# Some questions about EP applications and EP patents

- Practical example
- Amendments under EPC2000

Amendments under EPC2000

FIG. 1

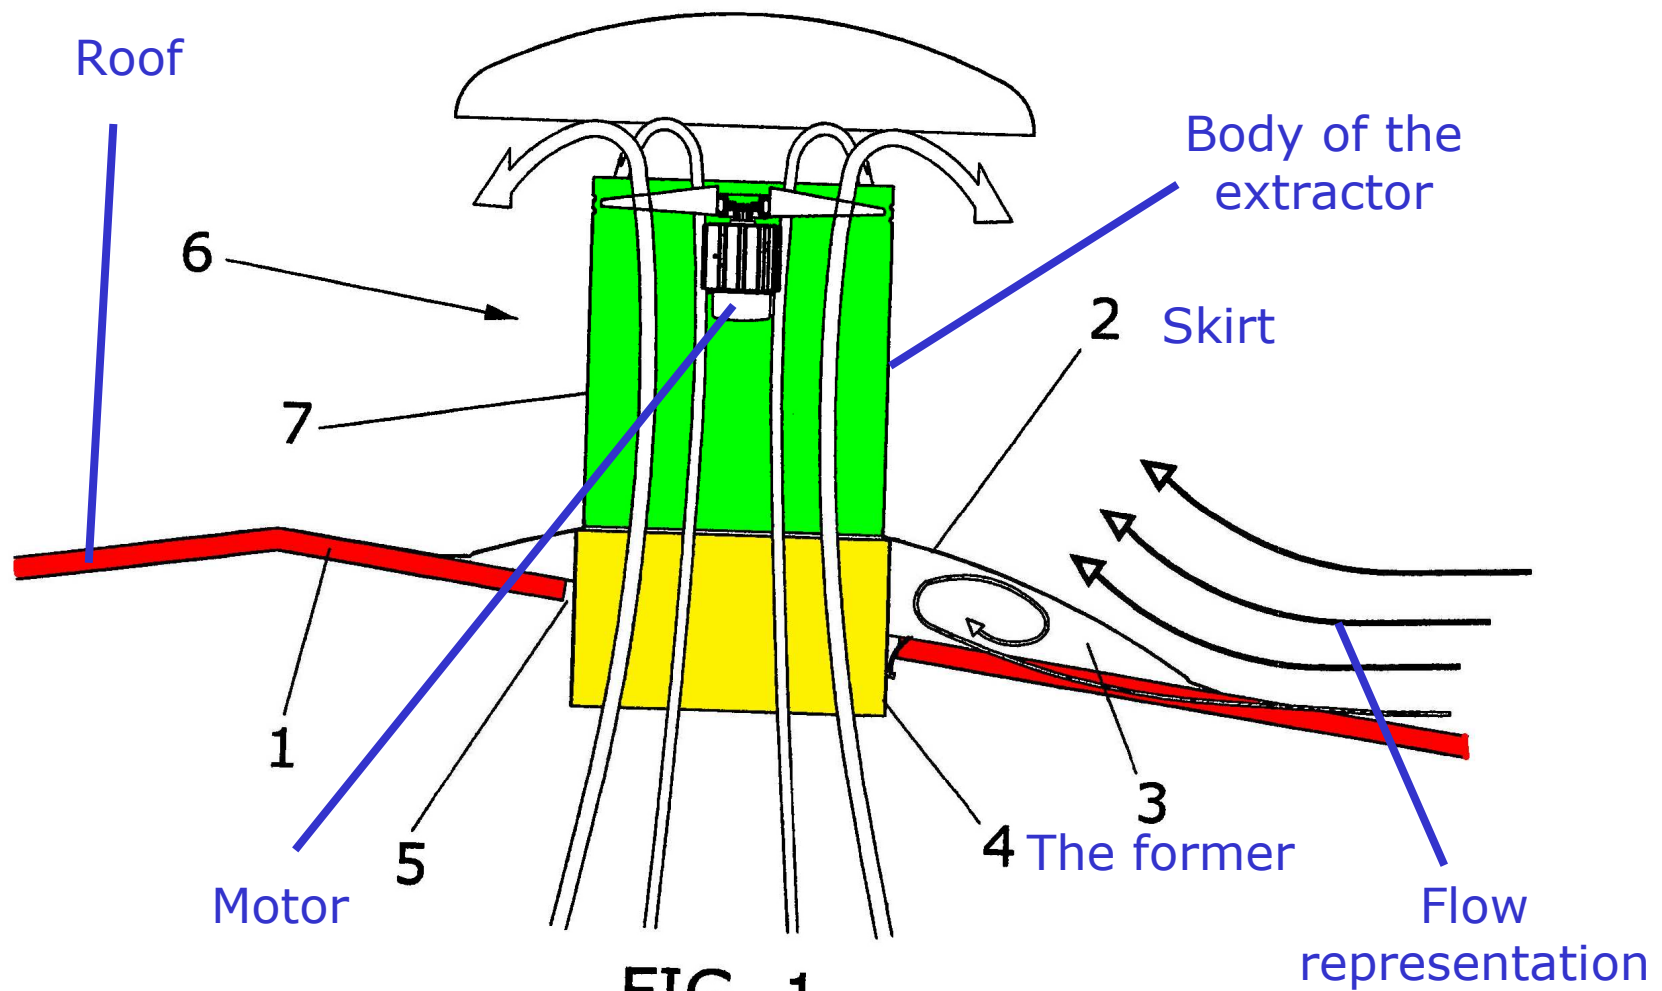
- In the claim, the roof is included to reference other parts, but, the roof do not owns to the claim. The claim can not be extended to the roof.
- The defense of Art 123(2) conformity was based on:
  - The description as filed did not include the wording of the last part of the claim.
  - Check that FIG 1 is the invention and FIG 2 is the state of the art.
  - Identify every part of the invention and the problem to solve in order to check the entrance of the air shower by the flow lines.

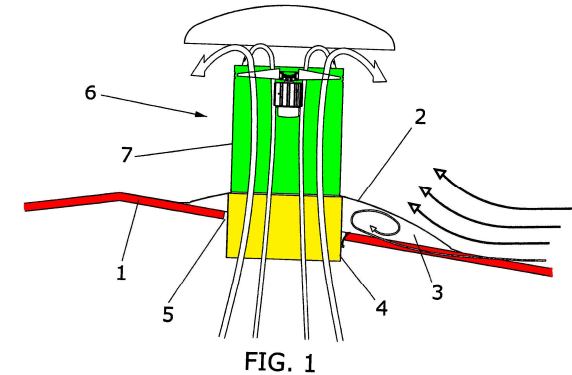
- Claim 1 appear to introduce subject-matter which extends beyond the content of the application as file, contrary to article 123(2) EPC. The text concerned is the following:

- “...allowing the penetration of the air between the lower edge of the skirt and the roof”.

- The original description does not describe such features. Nor can this feature be unambiguously interpret from the drawings.

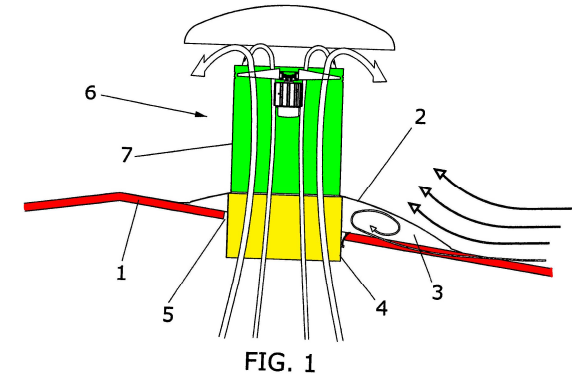
- The entrance of the air “by the lower edge” of the skirt can not be interpreted by the drawings. Only a sectional view is shown, not the complete configuration; therefore, the lower part in the sectional view can not be interpreted as the lower edge of the skirt. (Only one point of the edge is represented using a sectional view).

- 1.- Roof-mounted extractor or impeller with an air chamber comprising a body (7) which at its lower end has a skirt (2)

-A former (4) is connected over the body (7) of the extractor or impeller unit (6) on its end extremity, having both identical shape while the other end of the former (4) pass through a perforation (5) done on the roof, having the perforation (5) and the former (4) similar geometry

**characterized in that**

-A chamber (3) is formed being delimited on its lower part by the roof itself, on its upper part by the skirt (2) whose perimeter edge leans on the roof and laterally by the former (4) itself, **allowing the penetration of the air between the lower edge of the skirt (2) and the roof.**

- The scope of protection is wider.
- It is supported by the description + drawings
- Objections must be answered in the oral proceeding in the same order as they appear in the official action.

# Chimney

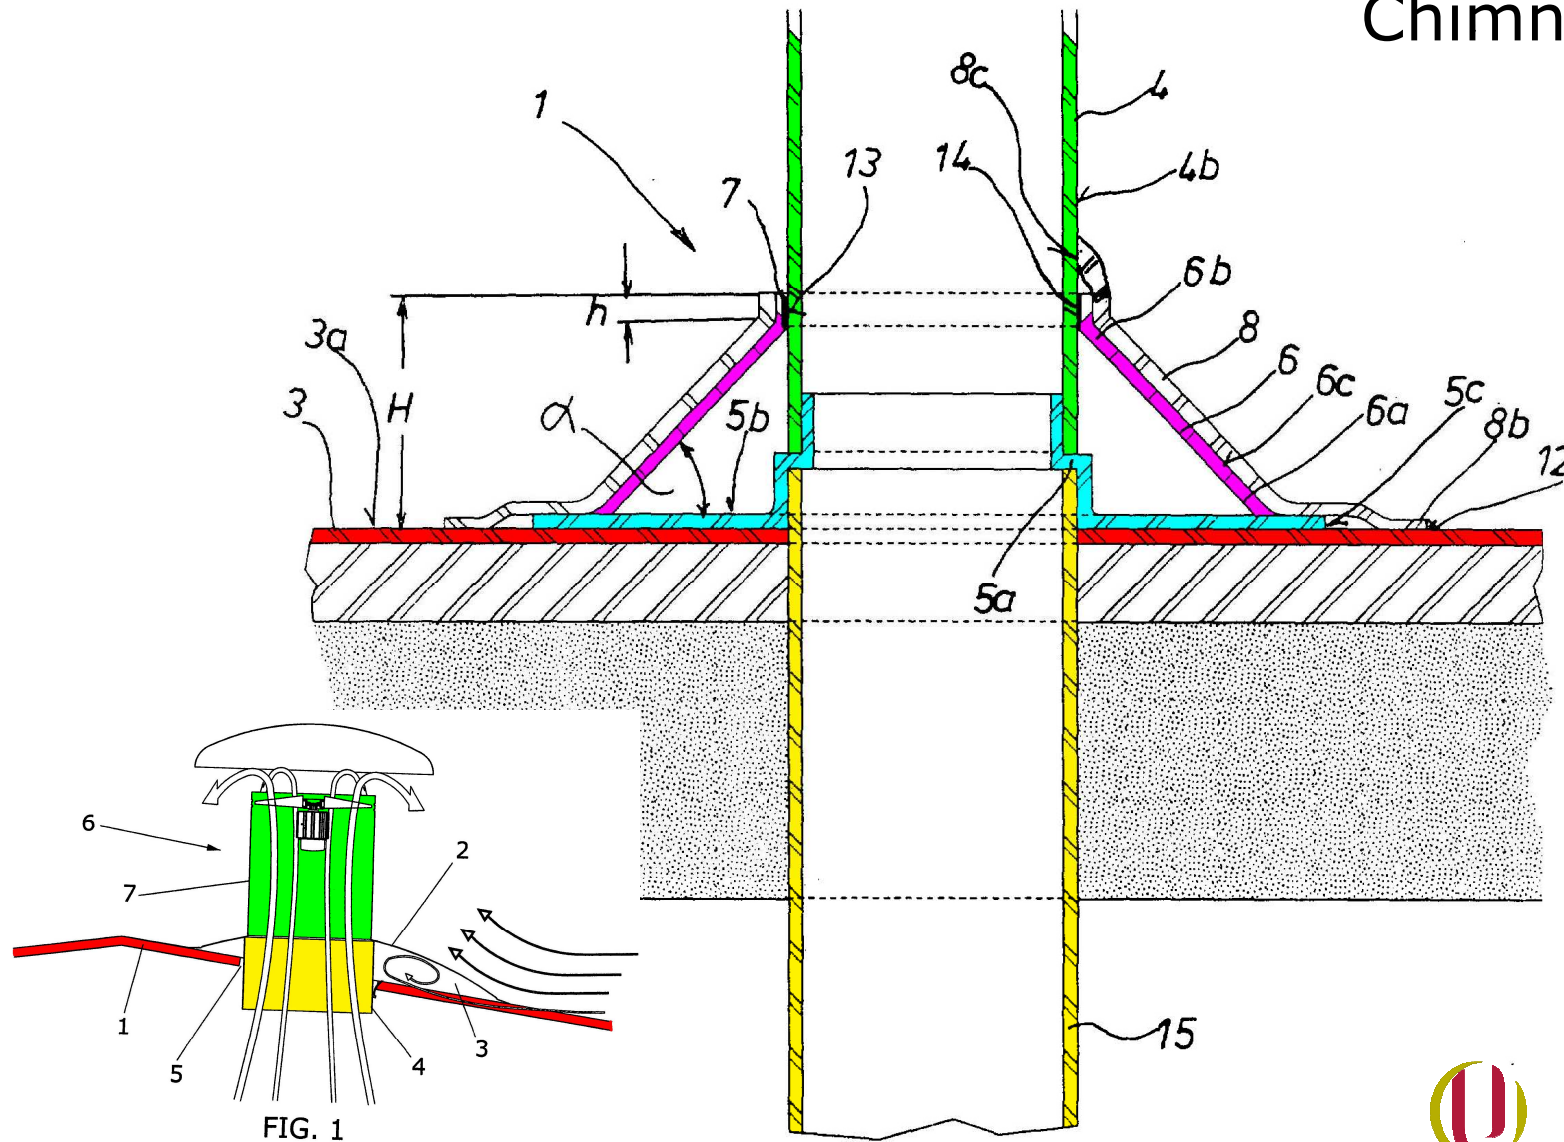
- Claim 1 is not new in the sense of Article 54(2) EPC. We have not discussed about novelty but this objection forces new amendments which are useful for our expositive purpose.
- D1 is considered as describing all the features of claim 1

Document D1 discloses in [ref] a roof-mounted **extractor or impeller** with an air chamber(10) comprising a body(4) which at **its lower end** has a skirt (6,8), —————→ **The skirt is not located at its lower end**

-A former (15) is connected **over** the body (4) of the extractor or impeller unit (100) on its and extremity, having both identical shape while the other end of the former (15) pass through a perforation done on the roof (3), having the perforation and the former (15) similar geometry, wherein

-A chamber is formed being delimited **on its lower part by the root itself (3)**, on its upper part by the skirt (6,8) whose perimeter edge leans on the roof (3) and **laterally by the former (15) itself**, allowing the penetration of the air between the lower edge of the skirt (6,8) and the roof.

D1 pasive device/invention active device

**There is an additional blue piece**

**The former is not in contact with the chamber**

- No novelty objections in view of D1
- The examining division agree with applicant arguments

Chimney

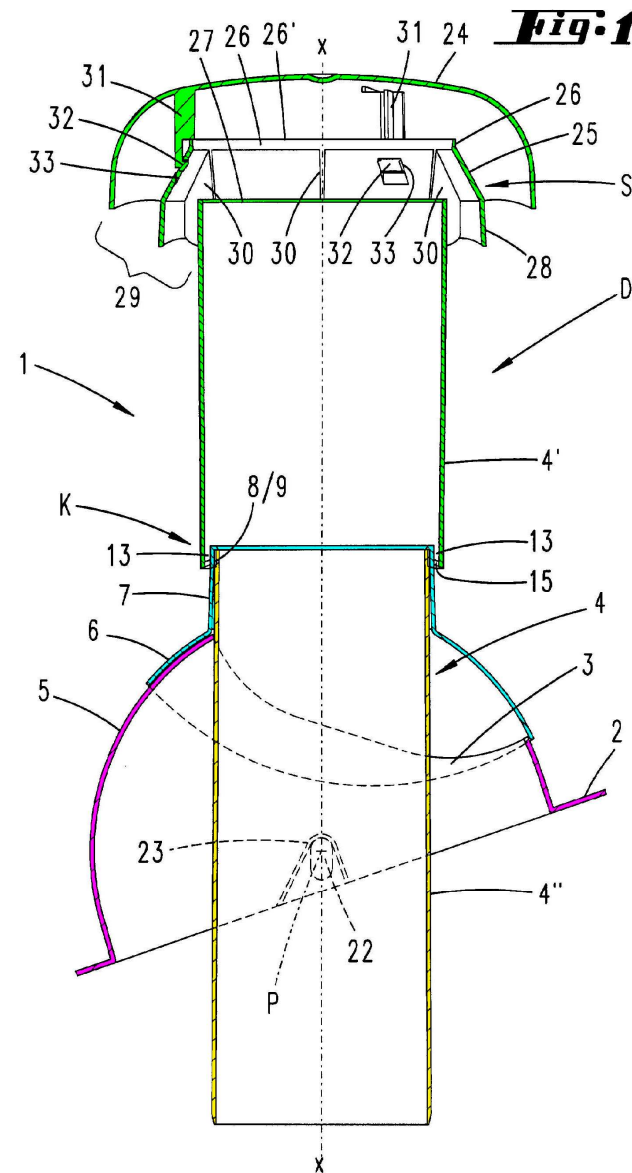
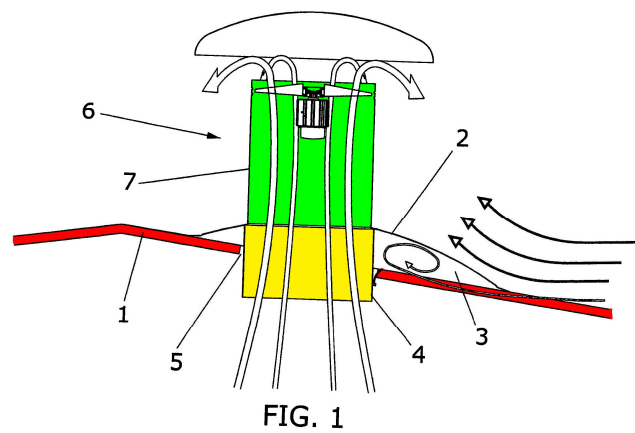
- Claim 1 is not new in the sense of Article 54(2) EPC.
- D2 is considered as describing all the features of claim 1

- 1.- Roof-mounted ~~extractor or~~ impeller with an air chamber comprising a body (7) which at its lower end has a skirt (2)
  - A former (4) is connected over the body (7) of the ~~extractor or~~ impeller unit (6) on its **upper** end extremity ~~having both identical shape while the other~~ lower end of the former (4) pass through a perforation (5) done on the roof, ~~having~~ the perforation (5) and the former (4) **having** similar geometry **and the former's lower end extremity being open**

**characterized in that**

- A chamber (3) is formed being delimited on its lower part by the roof itself, on its upper part by the skirt (2) whose perimeter edge leans on the roof and laterally by the former (4) itself, allowing the penetration of the air between the skirt (2) and the roof.
